# APPLICATION

SEWAGE DISPOSAL TESTING

DATE 11/26/85

SUBDIVISION River Downs LOT NO. X 4

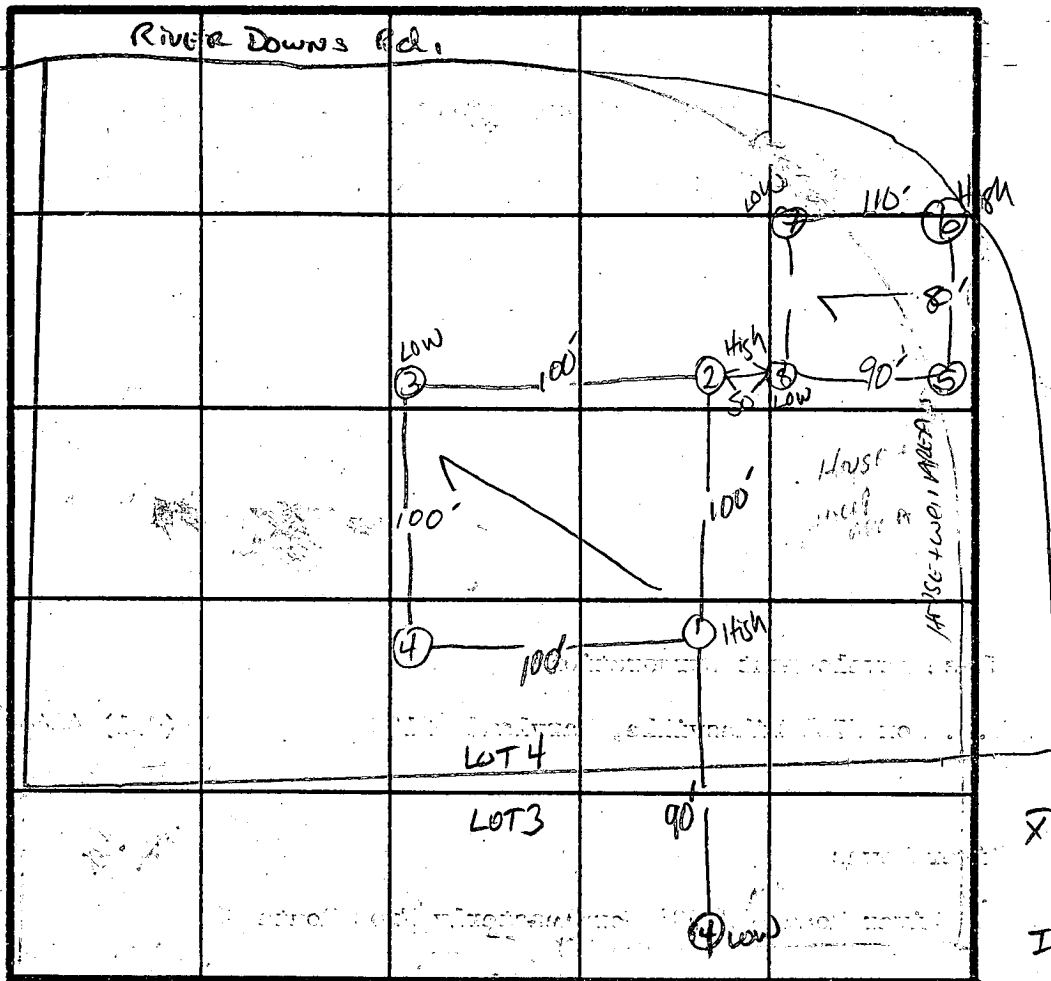
REASONS FOR REJECTION OR HOLDING 12-5-85 Perc in drainage area - Requires Redesigning. S. Albr

4-11-86 Perc Satisfactory, Holes located diff than plat hold for (certified) Subdivision Plat S. Albr

HOLE DIFF.  
FROM SURVEY  
2ND GROUP  
OF STAKES  
4-11-84  
S Abel

RECOMMEND REJECTION OF PERC. FIELD AS LOCATED - LOCATED IN SWAIL + DRAINAGE

REMARKS PERC AREA LOCATED AT BASE OF SWAIL, DRAINAGE BASIN; NET SEASON INSTRUCTION

APPROVED BY Srd Albr FOR Shallow tile fields DATE 1-2-87
